Product Change Notification: E-19-016902

PCN Date: 12-DEC-19

General Product Description:
RZ Relay

new version

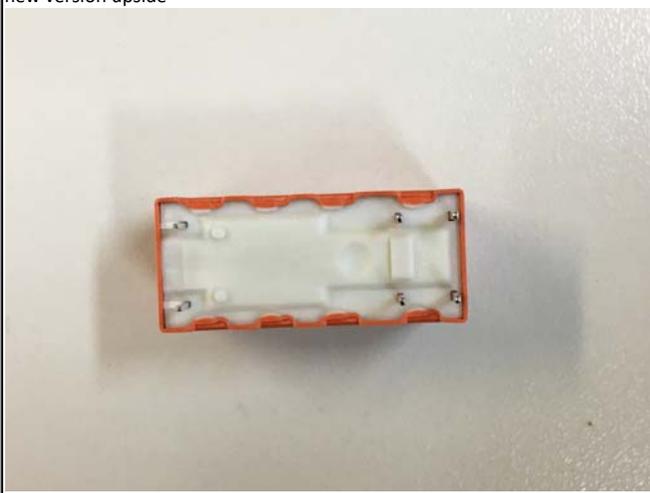
Description of Changes
Cover fixing of RZ relays will be slightly changed by increasing the length of the case hot embossing (see picture below). This supports production process stabilization as well as fixation strength of the case on the relay base (this change is not valid for RZ reinforced flux proof versions, e.g. RZ Haz Loc, RZ socketable and RZ -R). Additionally TE is changing the datecode format at RZ relay from four digits YYWW (Year-Year-Week-Week) to six digits to improve the traceability of produced relays. New format will show YYWWDS (Year-Year-Week-Week-Day-Shift). Example given: 19452B means Year 2019, Calendar Week 45, Tuesday, 2nd shift of this day. For detailed information regarding the change please contact your sales representative or Field Application Engineer. All parameters and approved performance/ratings remain unchanged.
